Traffic Impact Assessment

- Calderwood Project – Stage 1 PPR Addendum Traffic Impact Statement Update 8 February 2011
- Calderwood Urban Development Project Stage 1 Project Application Traffic Impact Assessment 4 March 2010

CALDERWOOD PROJECT – STAGE 1 PPR ADDENDUM TRAFFIC IMPACT STATEMENT UPDATE

FIGURE 1 PROPOSED CHANGES

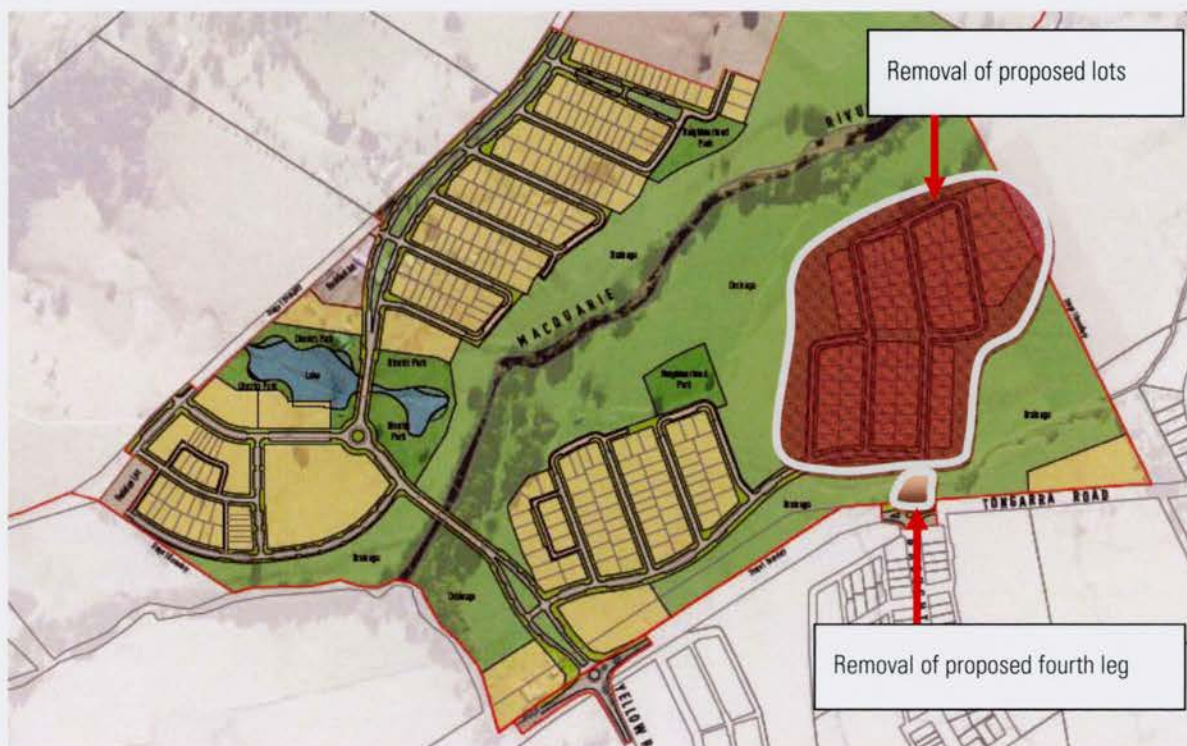
In accordance with your request, a review has been undertaken to determine the potential impact on the road network of the following changes to the Calderwood Urban Development Stage 1 Project Application as part of the Preferred project Report (PPR):

- Removal of land (refer to Figure 1) from the Stage 1 project application resulting in a reduction in the number of lots / dwellings.
- Removal of the proposed northern leg of the intersection of Illawarra Highway with Broughton Avenue/Illawarra Highway roundabout (refer to Figure 1), which would provide access to dwellings within Stage 1 of the Calderwood Urban Development area.

The Calderwood Urban Development Concept Plan modelling and traffic assessment includes a northern leg at the intersection of Illawarra Highway with Broughton Avenue. In Stage 1 this leg was proposed to provide access to new dwellings in the south-eastern area of the development site only. No connections to the east were proposed. The principal vehicular access to the Stage 1 site is proposed to be provided by constructing a four arm roundabout at the location of the current Illawarra Highway / Yellow Rock Road priority controlled intersection. This proposed northern leg of the intersection of Broughton Avenue/Illawarra Highway would have connected to the Illawarra Highway / Yellow Rock Road northern leg via the internal road network.

The removal of land and subsequent reduction in number of lots will reduce the traffic generating potential of the Stage1 site and hence will have no overall negative impact on the road network.

This review has considered the impact of removing the proposed northern leg from the intersection for the purpose of providing access to the proposed Stage 1 dwellings, as these dwellings will no longer be developed. The outcome of this review is that there will be no impact on the road network if this access is removed from Stage 1. The northern leg can be constructed at a time when the Tripoli Way bypass is required.
